PART NAME: Connector Box		REV: A+
P/N: C003-08		DATE: 11/29/16
DRAWN BY: D. Wenzel		
2:1		Aluminum 6061 - Anodized

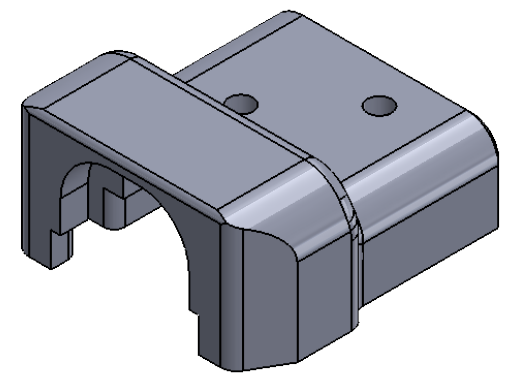
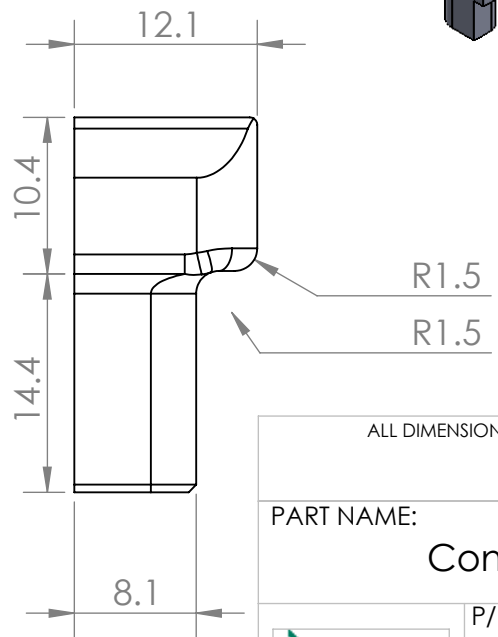
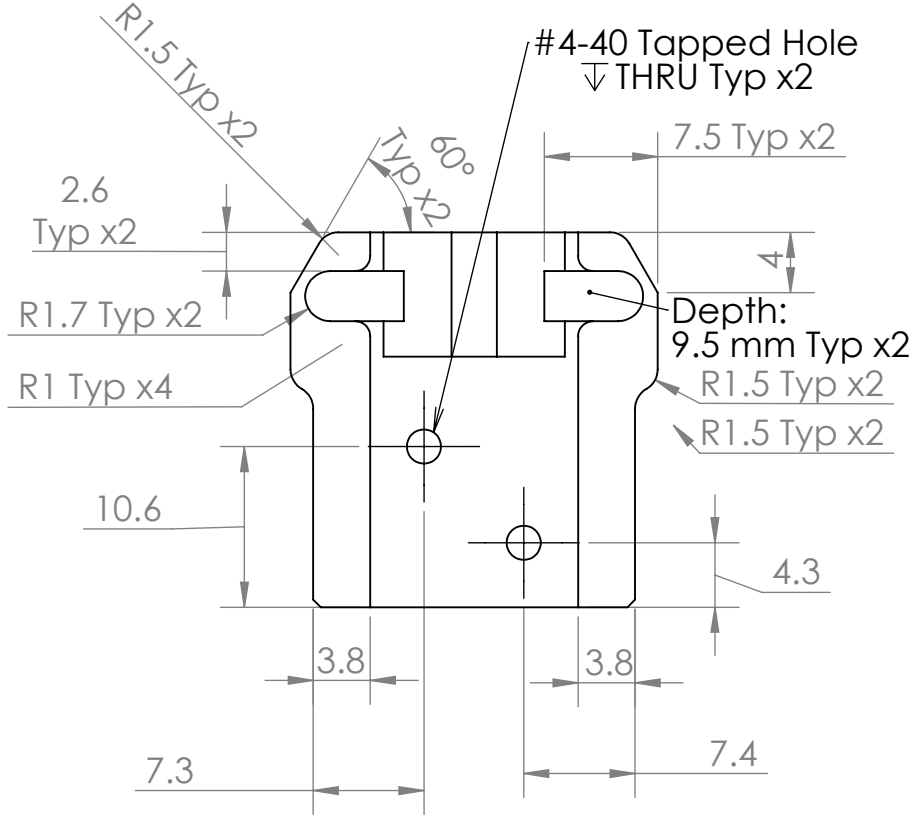
REV	CO#	DESCRIPTION	NAME	DATE
A	001	Initial Release	DW	8/10/16
B	002	Increased overall width and length to increase durability. Increased size of dowel pin interaction to accept 3/4" long dowel pin instead of 1/2" dowel pin. Increased opening for hub interaction. Added chamfers and fillets on box corners.	DW	10/20/16
